MONTGOMERY COUNTY HISTORIC PRESERVATION COMMISSION
STAFF REPORT

Address:	9403 Warren St., Silver Spring	Meeting Date:	3/26/2025
Resource:	Contributing Resource Linden Lane Historic District	Report Date:	3/19/2025
Applicant:	Cynthia Milloy	Public Notice:	3/12/2025
Review:	Historic Area Work Permit	Tax Credit:	Partial
Permit Number:	1092049	Staff:	Dan Bruechert
PROPOSAL: Partial demolition and construction of a new addition, and fenestration alterations.

Figure 2: Perspective drawings showing the proposed addition extending the existing roof slope.

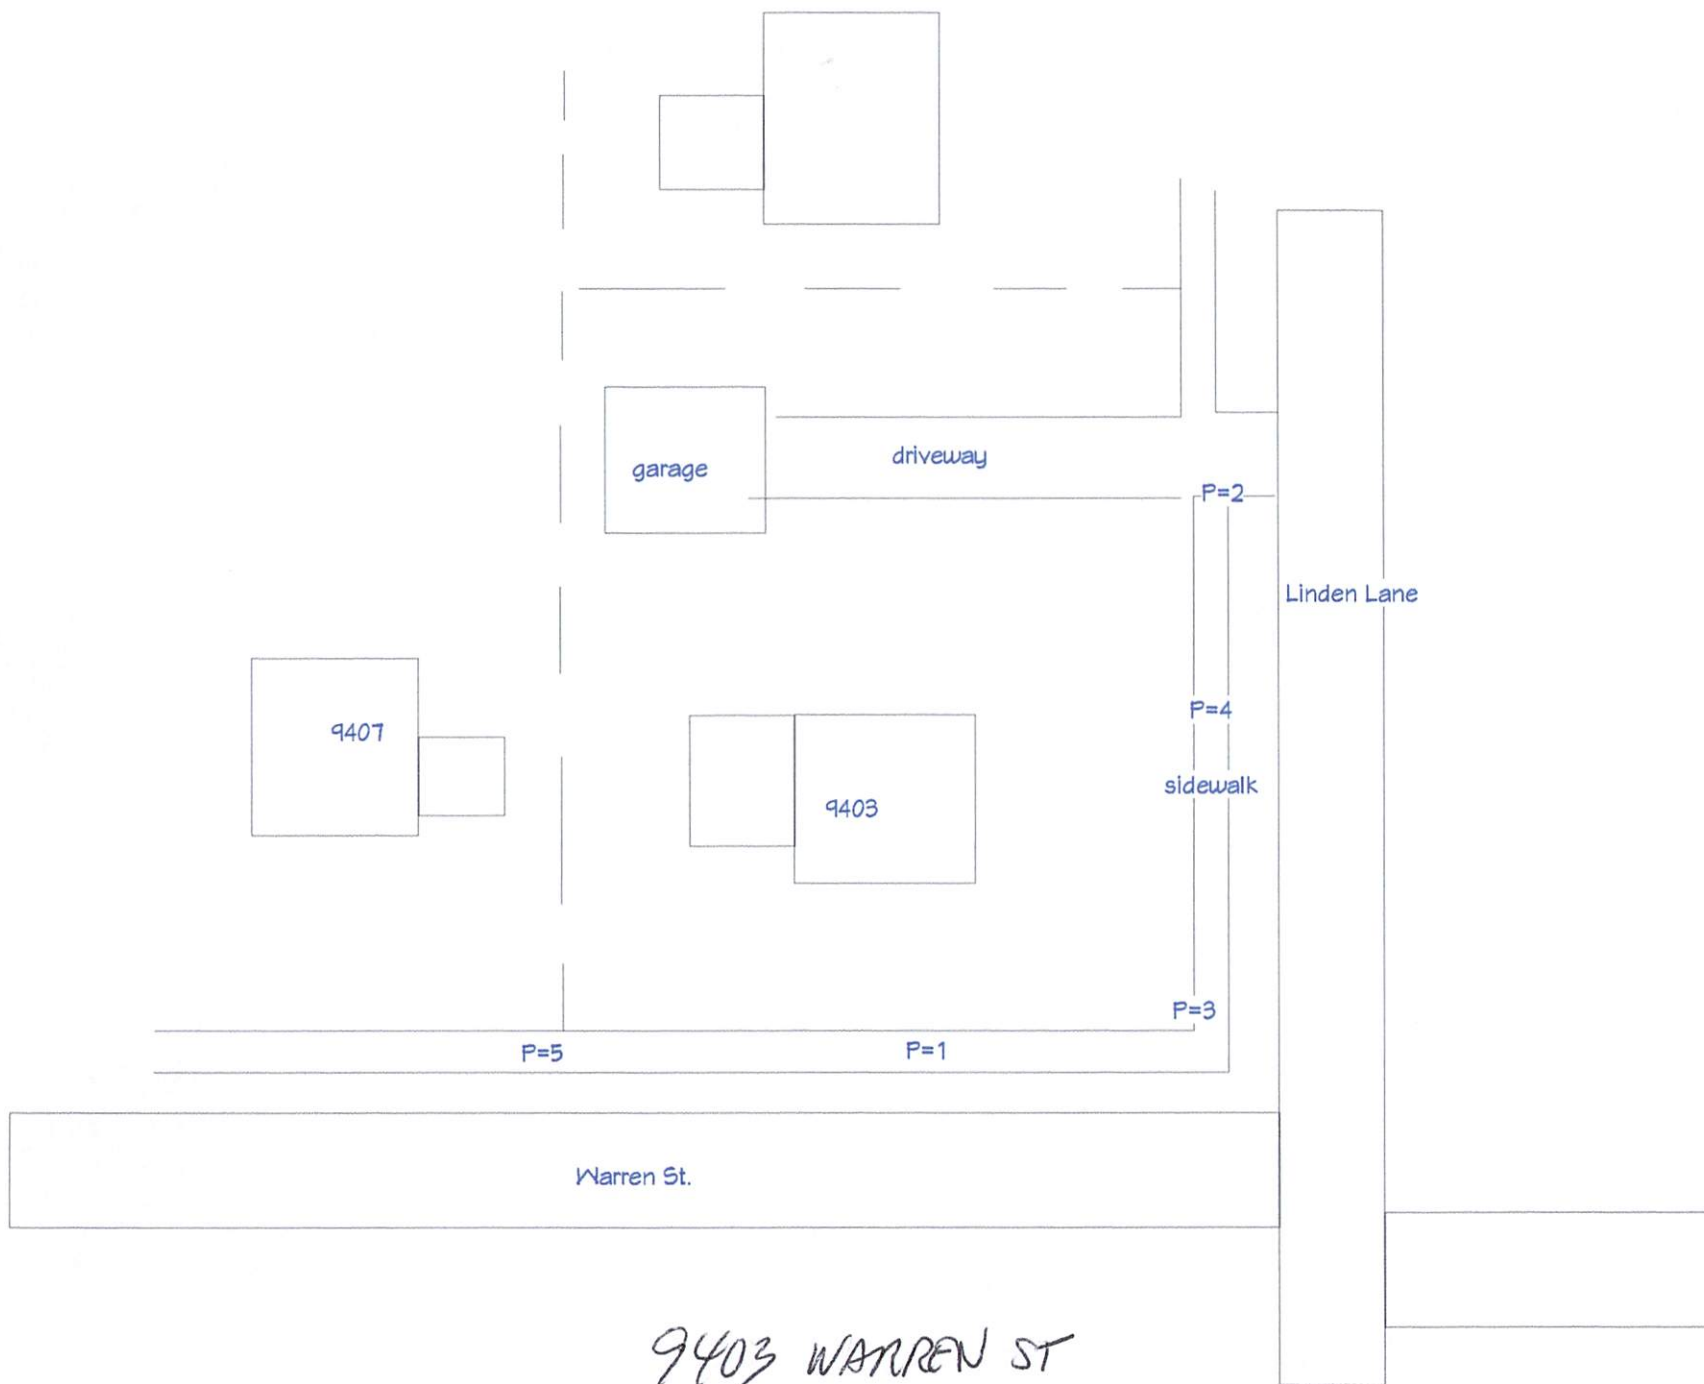
While Staff retains its position that the appropriate position for an addition to the subject property is off the rear, the applicant has revised their application in accordance with HPC guidance. . However, Staff finds that the rear roof slope appears to extend over the addition (see *Figure 2*, below) and is not sufficiently differentiated to the degree required by *Standard 9*. Staff recommends the HPC add a condition that requires the addition to be moved forward by at least 1' (one foot) so that the addition is at least 8' (eight feet) in front of the rear wall plane. This will ensure that the outline of the historic house, including its roof, is retained. This location would preserve the outline of the historic house as a district mass separate from the addition. Staff recognizes that this location is close to the one both the Staff and HPC found to be incompatible with the character of the house, however, Staff finds that if the HPC is willing to make findings that a side-projecting addition is appropriate in this instance, then extra steps should be taken to preserve the outline of the historic house.

1. The placement of the addition must be at least 8' (eight feet) forward of the rear wall plane to preserve the outline of the historic roof plane;
- under the Criteria for Issuance in Chapter 24A-8(d) and the purposes of Chapter 24A;
